SERVICE BULLETIN

No. 548

Piper Aircraft Corporation

Subject: Engine Control Rod End Bearing Inspection

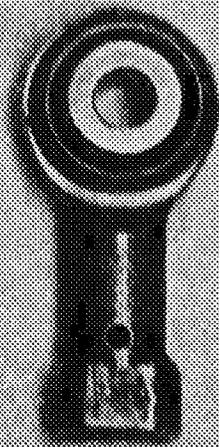
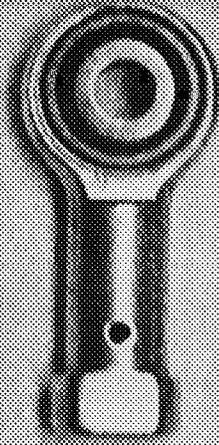
1. Gain access to the engine by opening or removing the cowling as required to conduct inspection.
2. Inspect the rod end bearing attached to the Mixture Throttle and Prop Governor (if applicable) Control Cables. (Refer to the picture attached to this Service Release.)
 - a. If a rod end bearing as identified in the picture as number two (2) (Brass Ball Retainer) or as number three (3) (Silver Ball Retainer) is installed then no

2. a. (continued)
further action is required. Make appropriate log book entry and return aircraft to service.

- b. If a rod end bearing - identified in the attached picture as number one (1) with a raised ball retainer is installed, it must be removed and replaced with a bearing listed in the Material Required, below. (Refer to the appropriate Piper Service Manual for proper replacement and rigging instructions.) Make appropriate log book entry and return the aircraft to service.

Note "raised" ball retainer

Material Required: For each control cable involved, one (1) Piper Part Number 452 557 Rod End Bearing (Heim HFV-3 or Seal Rod TR-3-39MX).
